From: Rose-Coss, Dylan, EMNRD
Sent: Thursday, December 22, 2022 8:54 AM
To: Gebremichael, Million, EMNRD
Subject: FW: [EXTERNAL] LFE
Attachments: SWD-2411_Longfellow Energy LP_AID State COM No 1-Order Sn.pdf; C-108_Muskegon_20_State_Com_1_SWD-2408_Approval.pdf

From: Steven Buckler <steven.buckler@longfellowenergy.com>
Sent: Wednesday, December 21, 2022 4:17 PM
To: Rose-Coss, Dylan, EMNRD <DylanH.Rose-Coss@emnrn.nm.gov>; David Cain <david.cain@longfellowenergy.com>
Subject: [EXTERNAL] LFE

Below is the rule in question. We have CBLs on both the aid state and Muskegon wells. Both have TOC well above the injection intervals as shown in the wellbore diagrams below. We just want to understand that no further cement remediation is required before moving forward.

Muskegon WBD sent to OCD/UIC

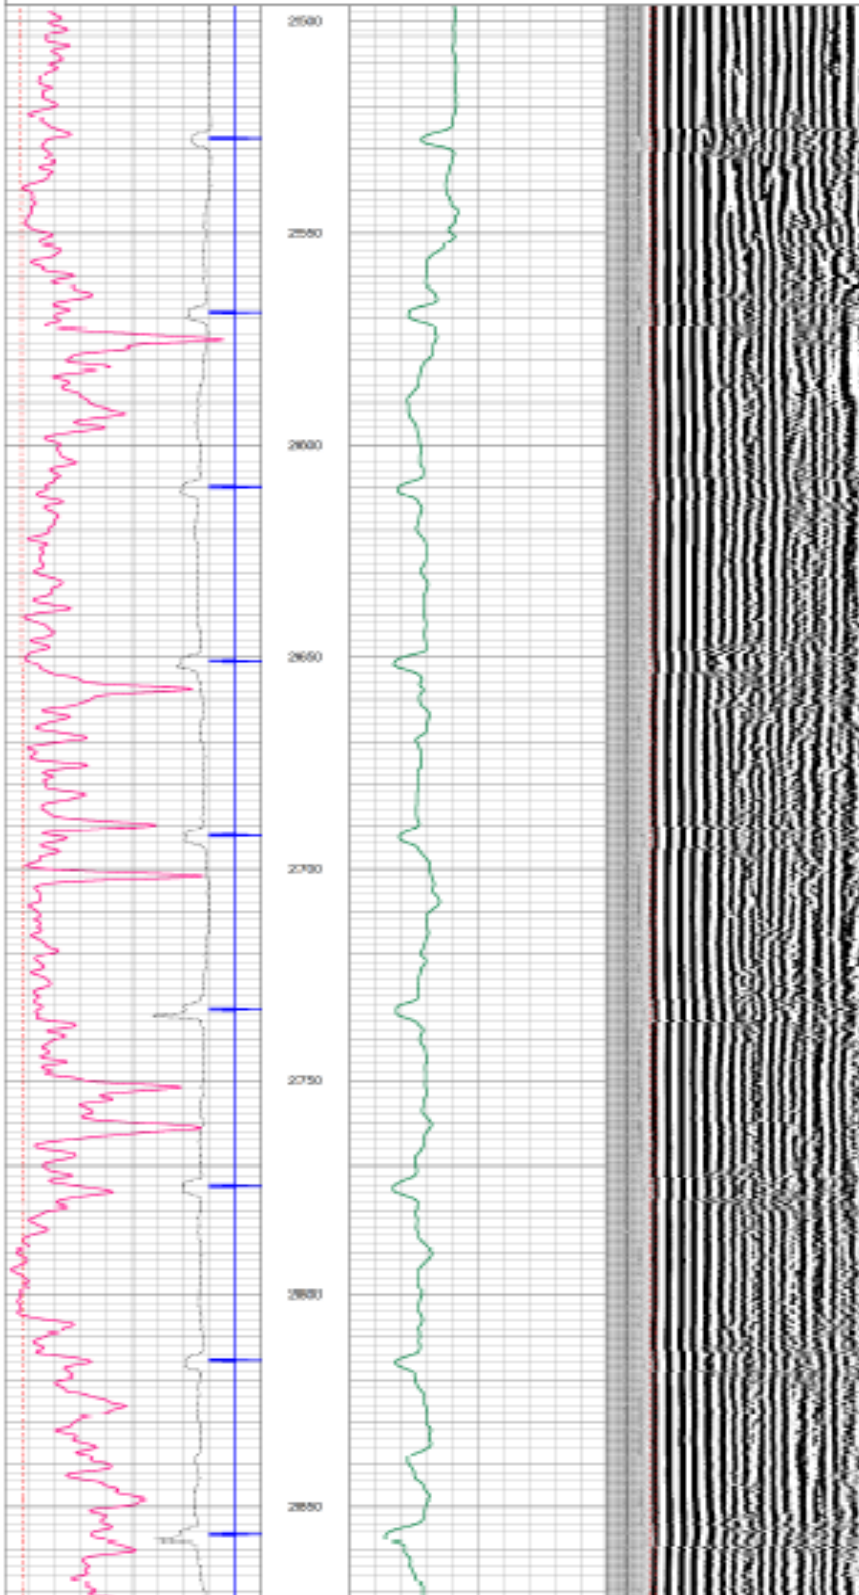
b. Permittee shall circulate to surface the cement for the surface and intermediate casings. If cement does not circulate on any casing string, Permittee shall run a cement bond log ("CBL") to determine the top of cement, then notify the OCD Engineering Bureau, the appropriate OCD Inspection Supervisor, and submit the CBL prior to continuing with any further cementing on the Well. If the cement did not tie back into next higher casing shoe, Permittee shall perform remedial cement action to bring the cement to a minimum of two hundred (200) feet above the next higher casing shoe.
